Modification to Minister's Approval

Application Number: MP 06_0228
Proponent: Shoalhaven Starches Pty Ltd
Approval authority: Minister for Planning
Project: Shoalhaven Starches Expansion Project
Date of original approval: 29 January 2009
Modification: MP 06_0228 MOD 10 – Flour Mill B

APPENDIX 2J – SITE PLANS (MP 06_0228 MOD 10)

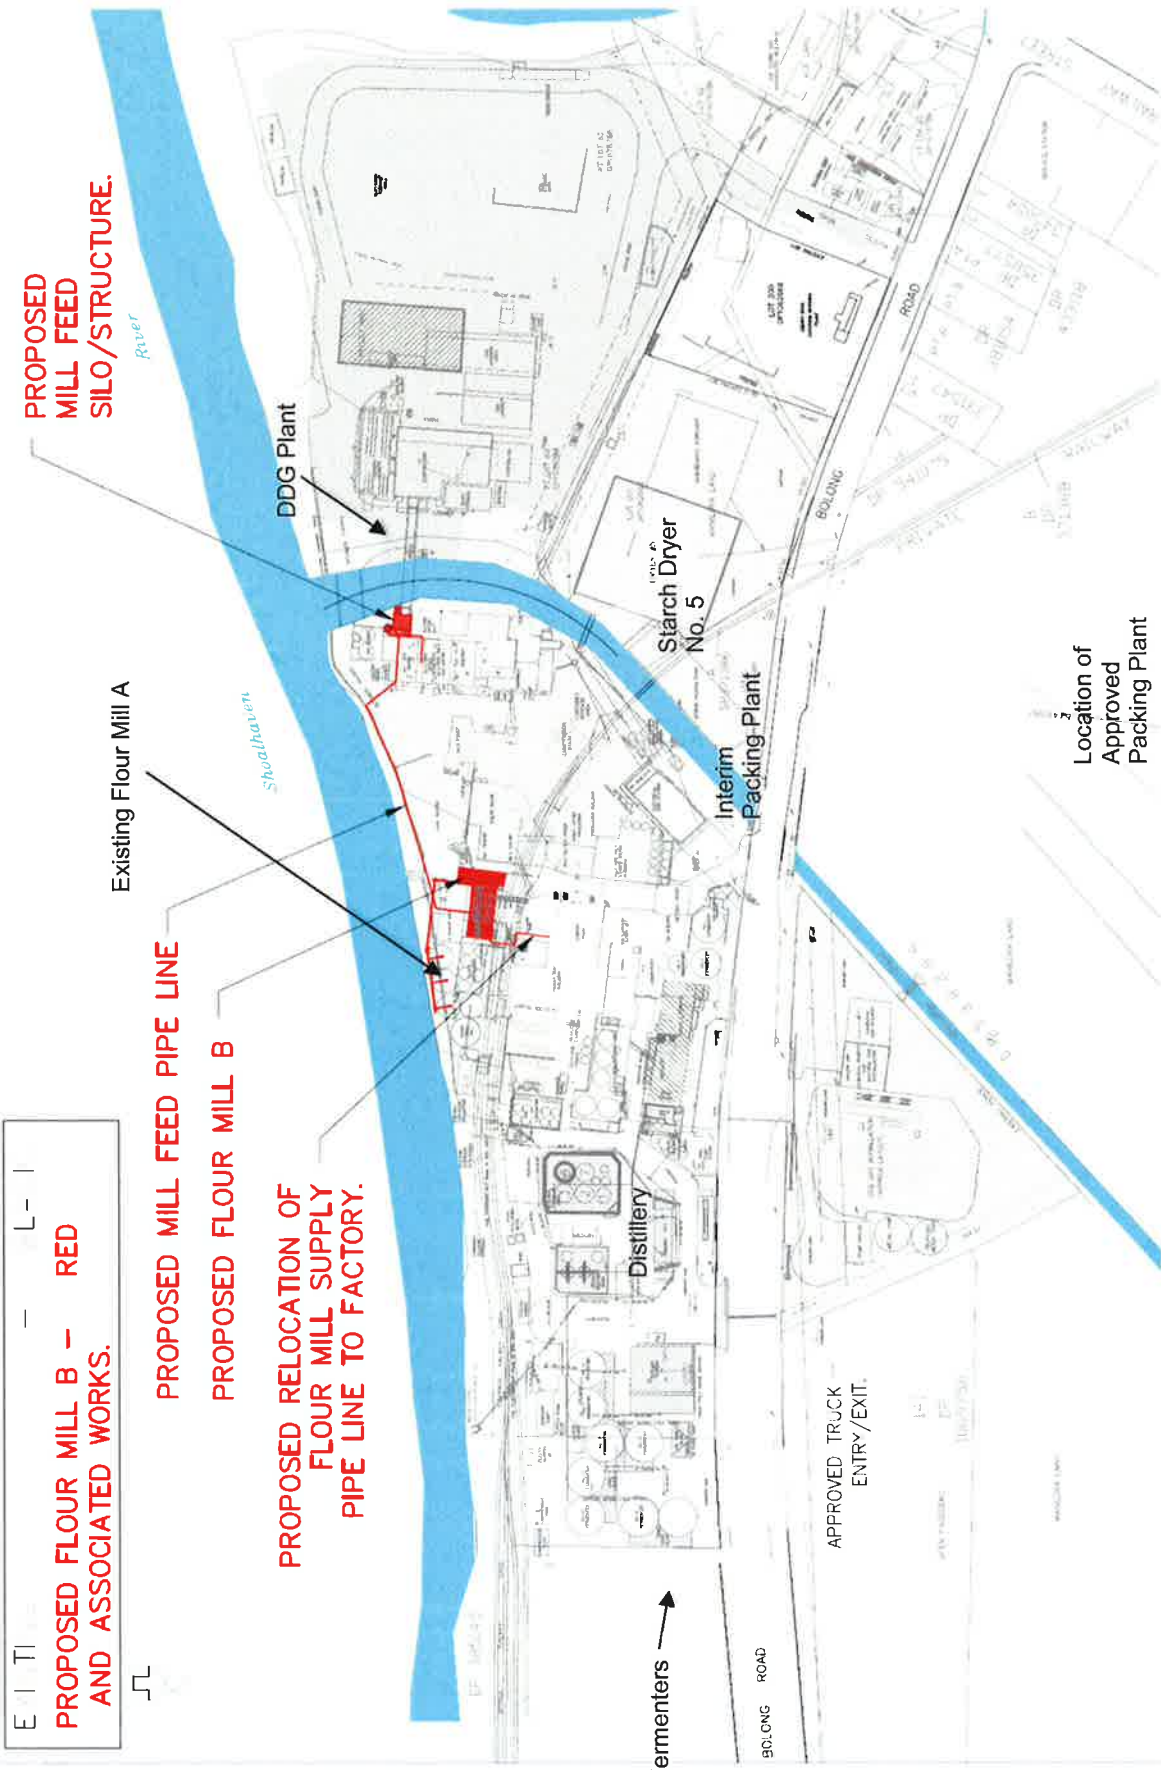
Location of Approved Packing Plant

Location of Flour Mill B and Mill Feed Structure

EXISTING APPROVED PLAN.

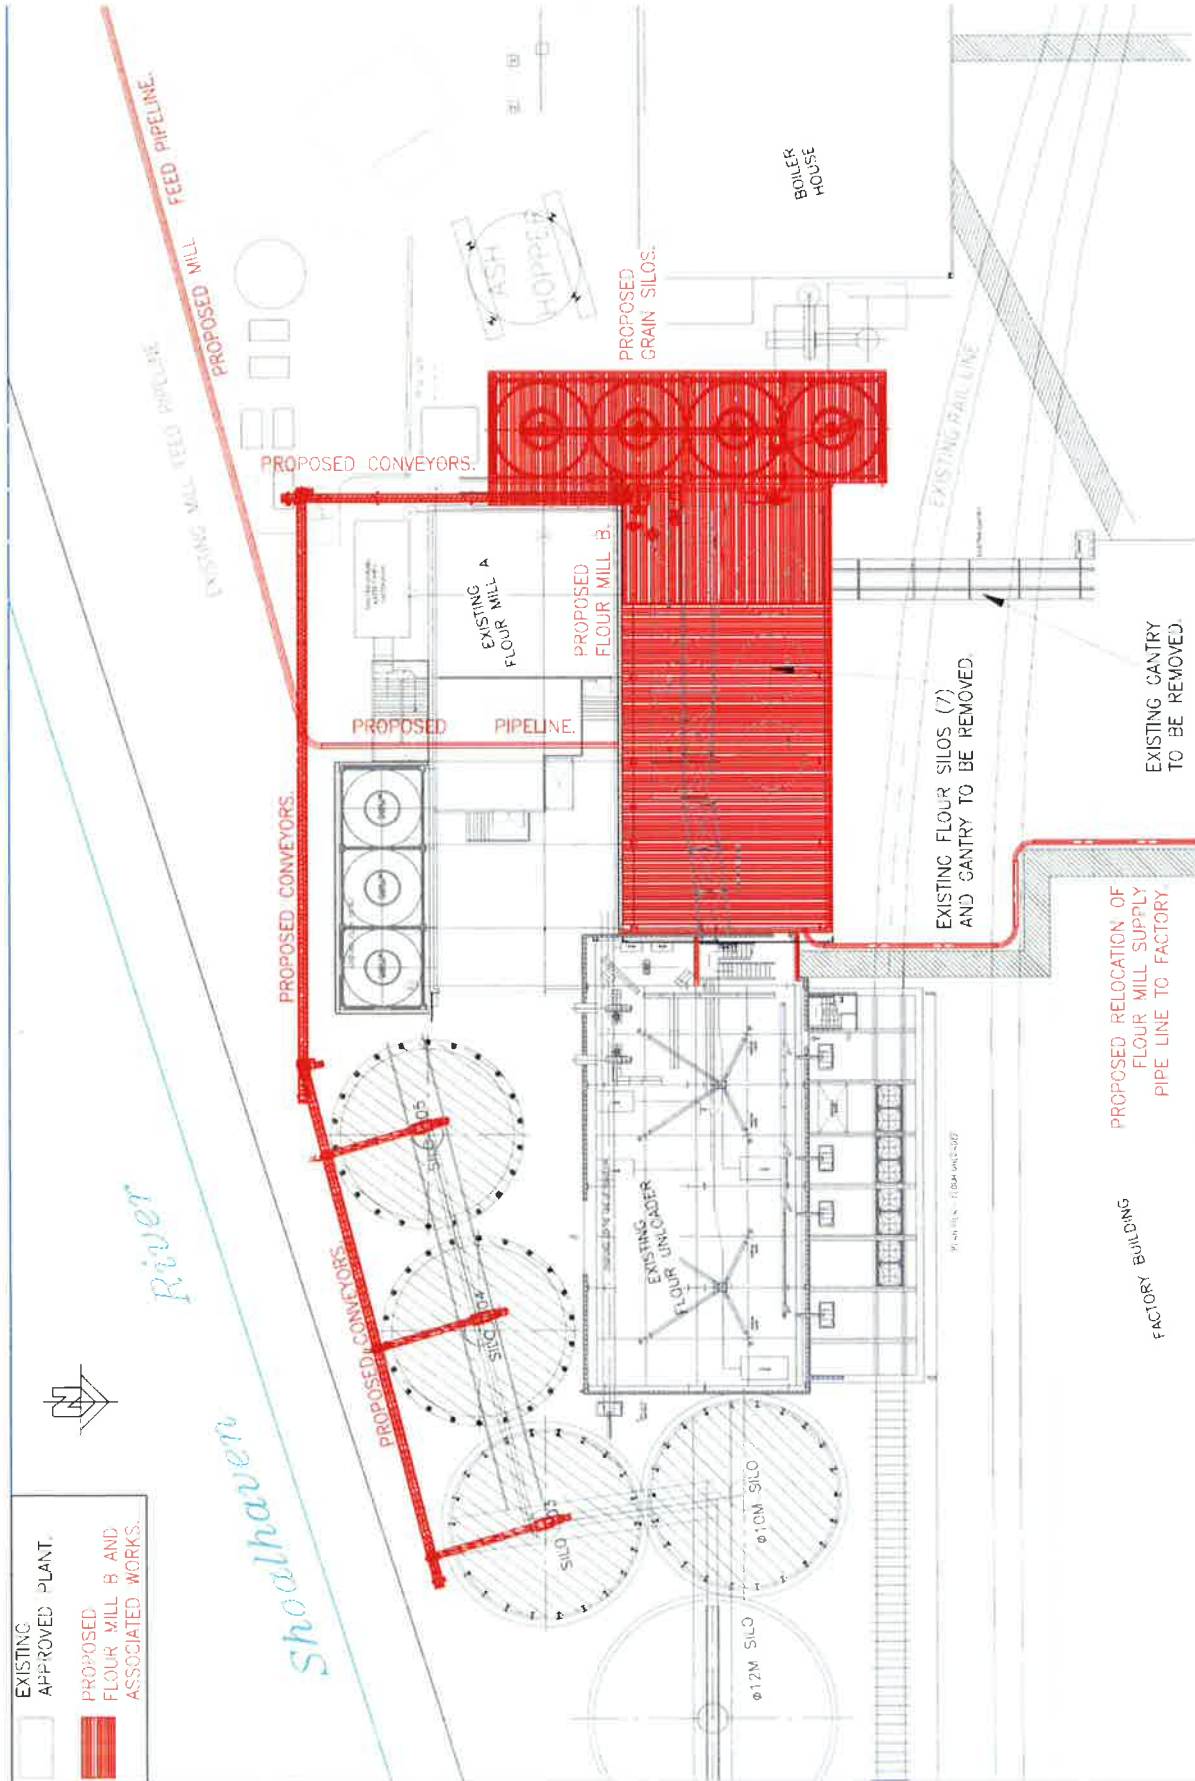
PROPOSED FLOUR MILL B AND ASSOCIATED WORKS.

EXISTING CENTRY TO BE REMOVED.

EXISTING FLOUR SILOS (?) AND CENTRY TO BE REMOVED.

Northern Elevation of Flour Mill B

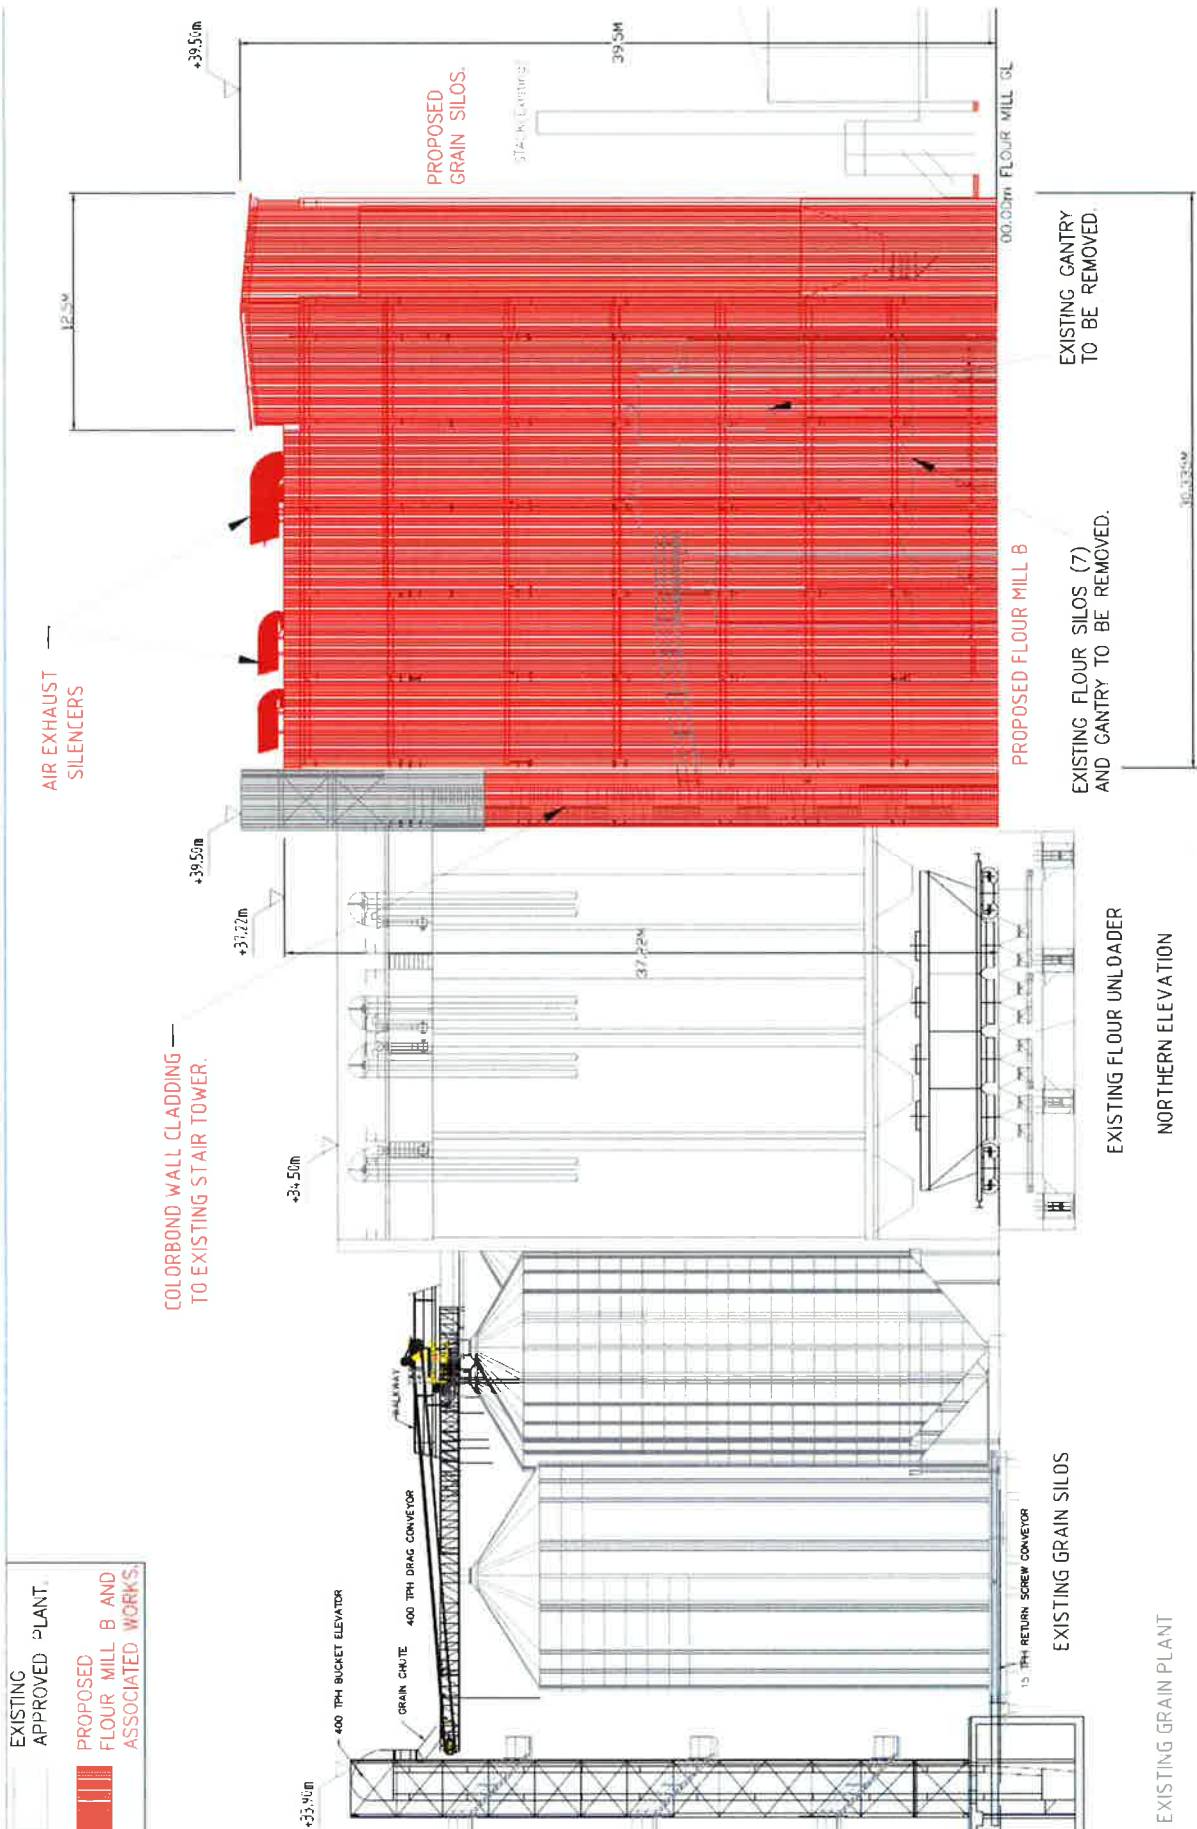
PROPOSED RELOCATION OF FLOUR MILL SUPPLY PIPE LINE TO FACTORY.

EXISTING CENTRY TO BE REMOVED.

Flour Mill B

EXISTING APPROVED PLANT

PROPOSED FLOUR MILL B AND ASSOCIATED WORKS

Mill Feed Structure

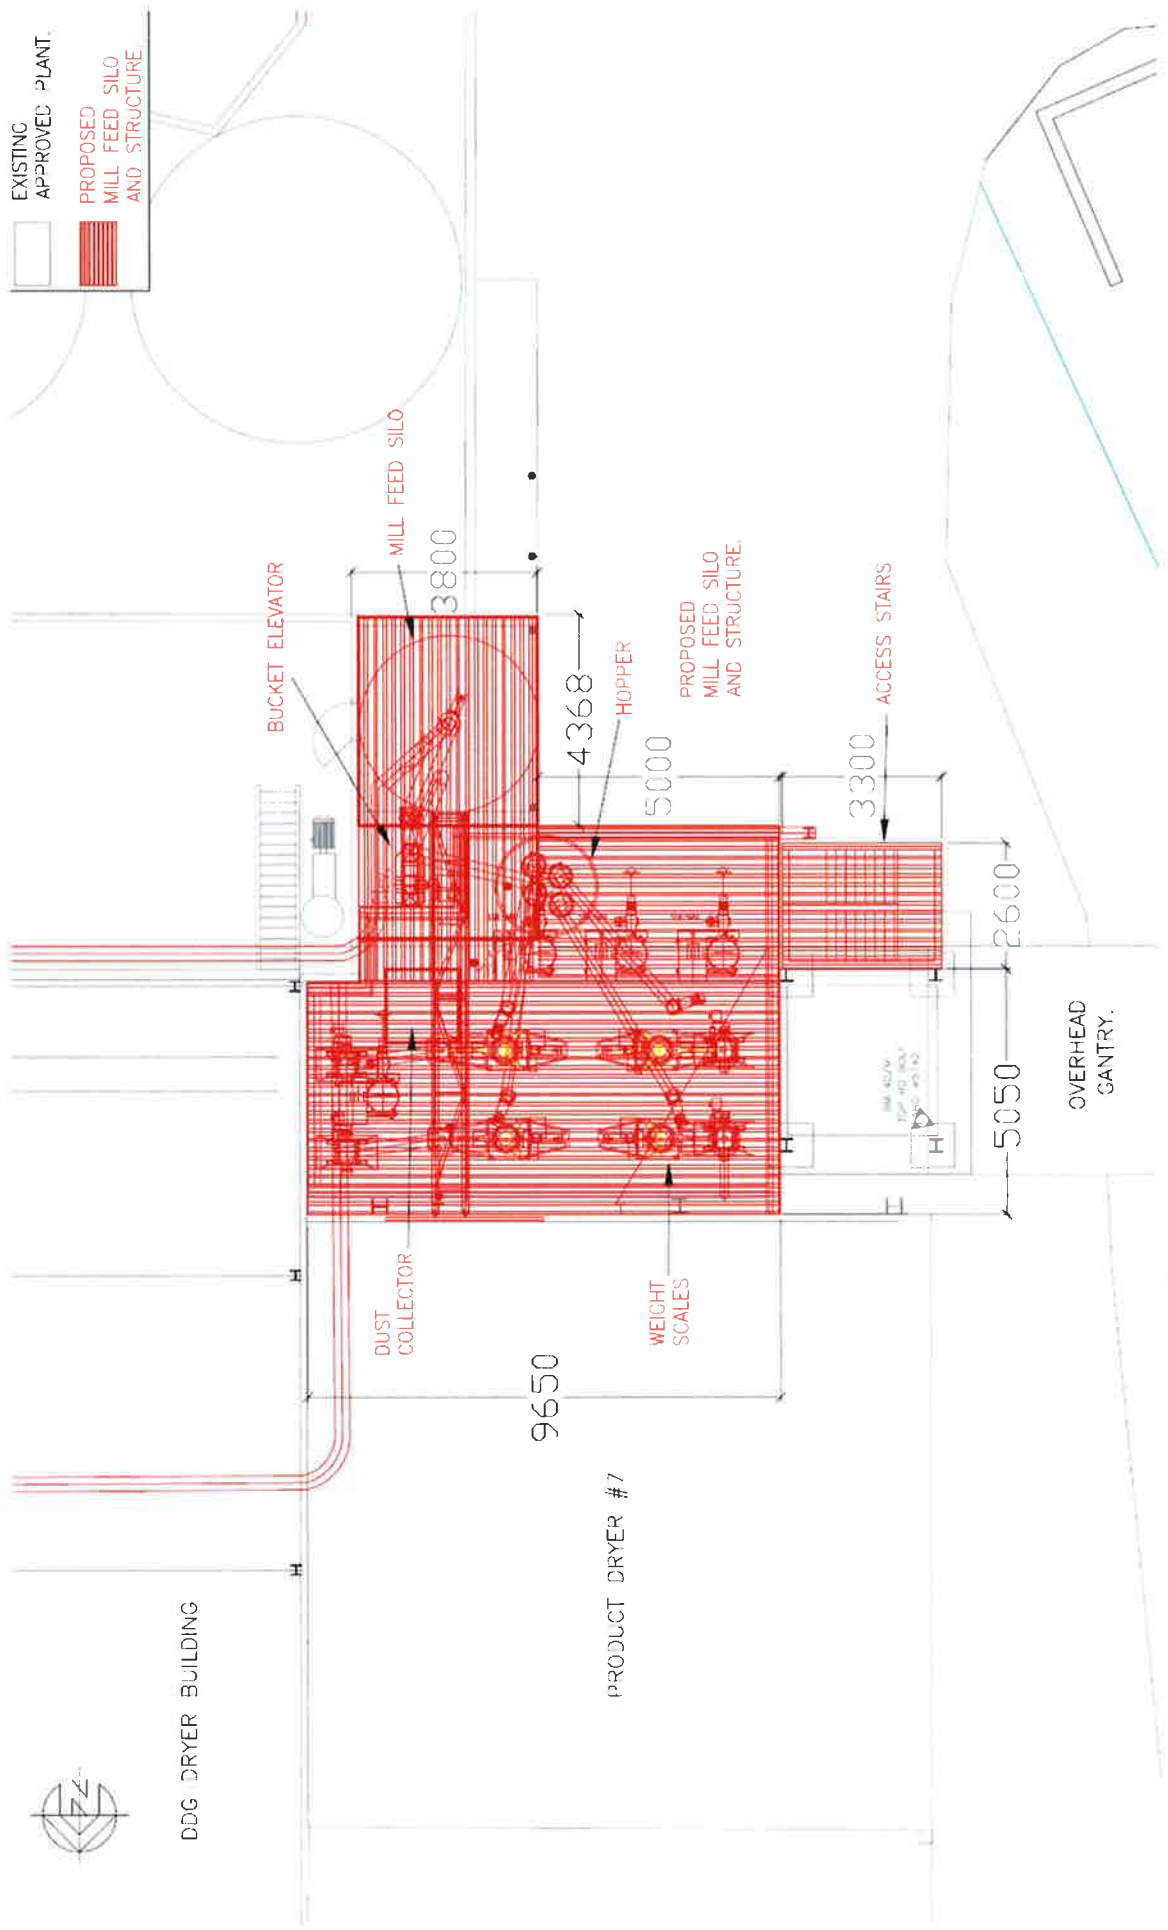
DDG DRYER BUILDING
